Access Compliance Report

Public Rights-of-Way

(Curb Ramps)

Intersection ID: 23117	Main Street: CEDAR_CROSSINGS_DR	Cross Street: ERWIN_RD	Location: SE
ADA ID: C19789630EB4	Ramp Type: PerpDiag	Initial Pass/Fail: Fail	Overall Compliance: No
Severity Score: 35			
Codes/Mitigation Info/Possible Solution		Field Measurements/Component Compliance

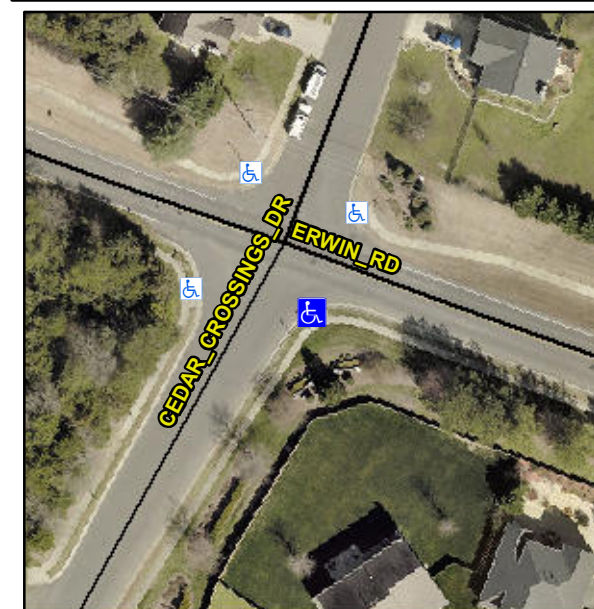
R304.5.1, R304.2.2, R304.5.3

Compliance	Description	Data	Compliance	Description	Data
N/A	Ramp Length (in)	47.0	No	Ramp Slope (%)	12.3
No	Ramp Width (in)	42.0	No	Ramp XSlope (%)	4.5
N/A	Flare Type LT	N/A	N/A	Flare Type RT	N/A
N/A	Flare Slope LT (%)	N/A	N/A	Flare Slope RT (%)	N/A
N/A	Flare Traversable LT?	N/A	N/A	Flare Traversable RT?	N/A
N/A	Landing Length (in)	N/A	N/A	DWS Provided?	N/A
N/A	Landing Width (in)	N/A	N/A	DWS Contrast?	N/A
N/A	Landing Slope (%)	N/A	N/A	DWS Length (in)	N/A
N/A	Landing X Slope (%)	N/A	N/A	DWS Full Width?	N/A
N/A	Landing Curb? (Y/N)	N/A	N/A	DWS Offset (in)	N/A
N/A	Shared Landing?	N/A			
N/A	Gutter Ponding?	N/A	N/A	Gutter Slope (%)	N/A
N/A	Gutter Lip Ht (in)	N/A	N/A	Gutter X Slope (%)	N/A
N/A	Painted X Walk1?	No	N/A	Painted X Walk2?	No
	X Walk 1 Direction	To NE		X Walk 2 Direction	To NW
N/A	X Walk 1 Width (in)	N/A	N/A	X Walk 2 Width (in)	N/A
	X Walk 1 Slope (%)	5.4		X Walk 2 Slope (%)	0.9
	X Walk 1 X Slope (%)	0.4		X Walk 2 X Slope (%)	4.6

N/A	Ramp inside XWalk1?	N/A	N/A	Ramp inside XWalk2?	N/A
	Road Slope (%)	3.8	N/A	Clear Space?	N/A
	Road X Slope (%)	4.9	N/A	Clear Space to XWalk (in)	N/A
N/A	Any Obstructions?	N/A	N/A	Storm Grate/Utility Hazard?	N/A
	Obstruction Type			Storm Grate/Utility Type	
		N/A			N/A
			Yes	Surface Condition? (G/P)	Good

Remove & Replace Curb Ramp With Two New Directional Ramps or Equivalent.
